# 160 BURWOOD RD, CONCORD URBAN DESIGN REVIEW

## Final Report

Prepared for the City of Canada Bay Council  
by Studio GL

Job title	Urban Design Review 160 Burwood Road, Concord
Client	City of Canada Bay
Job number	20063
Report title	Draft Urban Design Review Report
File name	20063_BurwoodRd_UrbanDesignReview_PP2022.indd

Figure 67 Concept Plan elevation and section (BVN 2022) overlaid with PP (May 2022) LEP maximum Height of Building (in blue) and Studio GL's recommended maximum LEP building heights 2022 (in red)

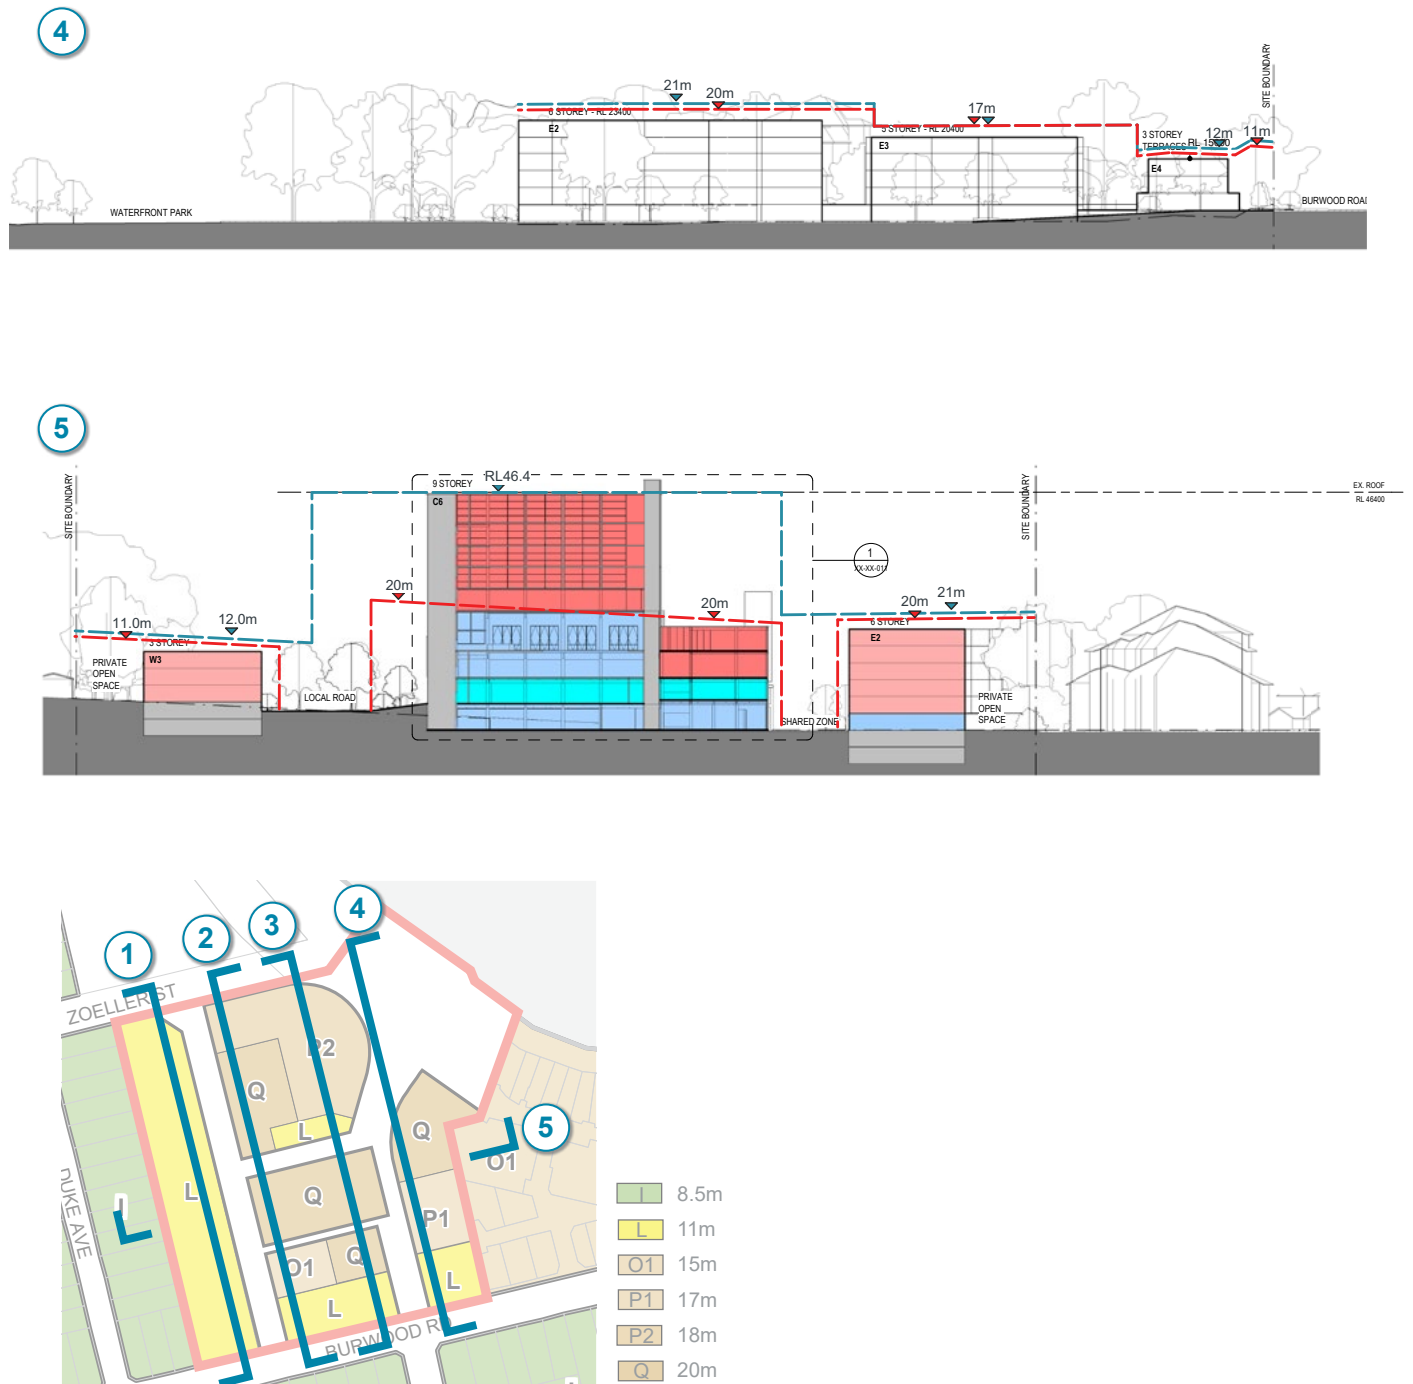
The maximum building heights in the proposed amended LEP map identified in the PP (May 2022) are greater than needed to accommodate the proposed built form and could, potentially, encourage even taller development in the future. To avoid this the following is recommended (as shown in Figure 64):

Figure 69 Recommended FSR map prepared by Studio GL, 2022

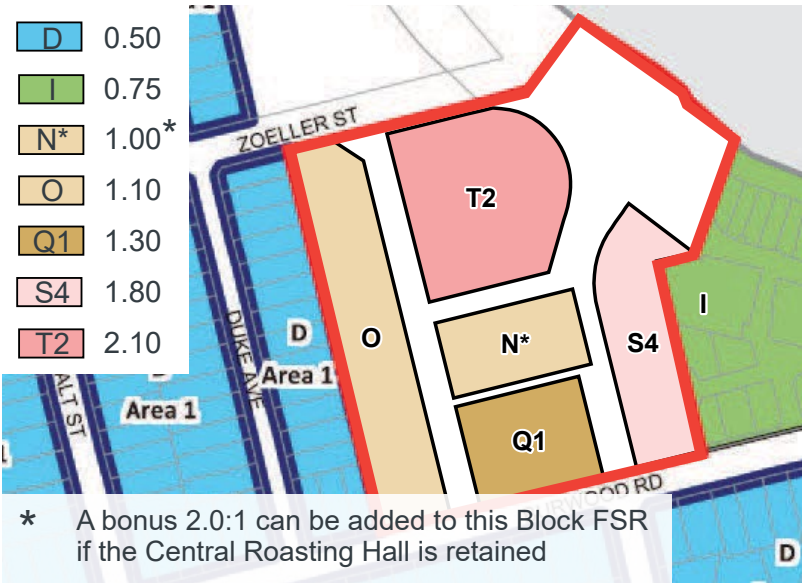
It is recommended that FSR in the CBLEP is identified per block to ensure lower FSRs are located next to the sensitive interfaces with higher FSR for Block 5 and the Central Roasting Hall similar to the diagram shown in Figure 69. These recommendations should also be reflected in the draft DCP FSR Block diagram as suggested in Figure 71.

Figure 72 Recommended site layout prepared by Studio GL with building envelopes used to calculate FSR

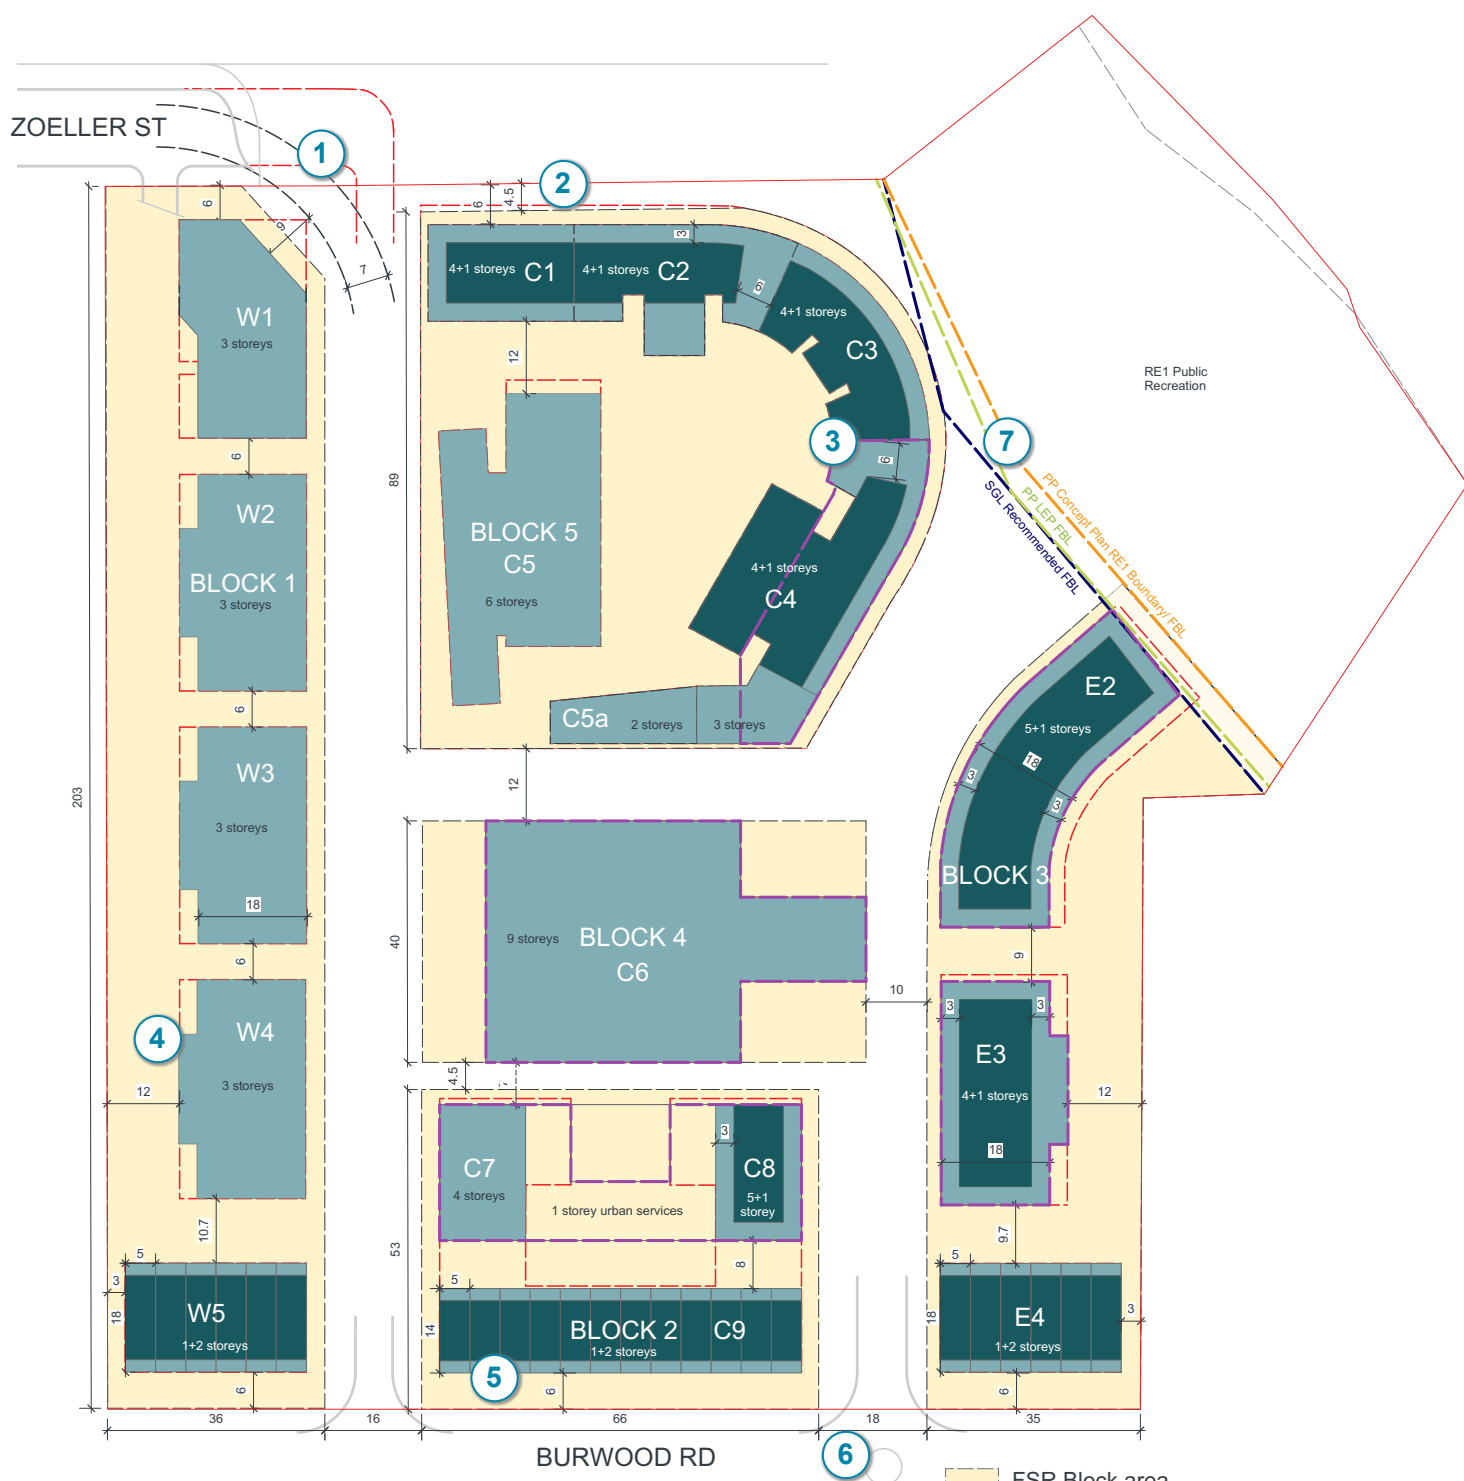
Studio GL also recommends upper level setbacks for apartment buildings as shown in Figure 72 for buildings generally over 4 storeys. This will help reduce the overall bulk and scale, minimise overshadowing and reduce the sense of enclosure for pedestrians at street level.

As shown in Figure 72, Studio GL recommends reducing some of the overall building depths shown in the concept designs to accommodate balconies within the building envelopes and avoid encroachments into the sensitive side setbacks.

Separation distances should also be increased as suggested in Figure 72 where they do not achieve the minimum criteria set out in the Apartment Design Guide.
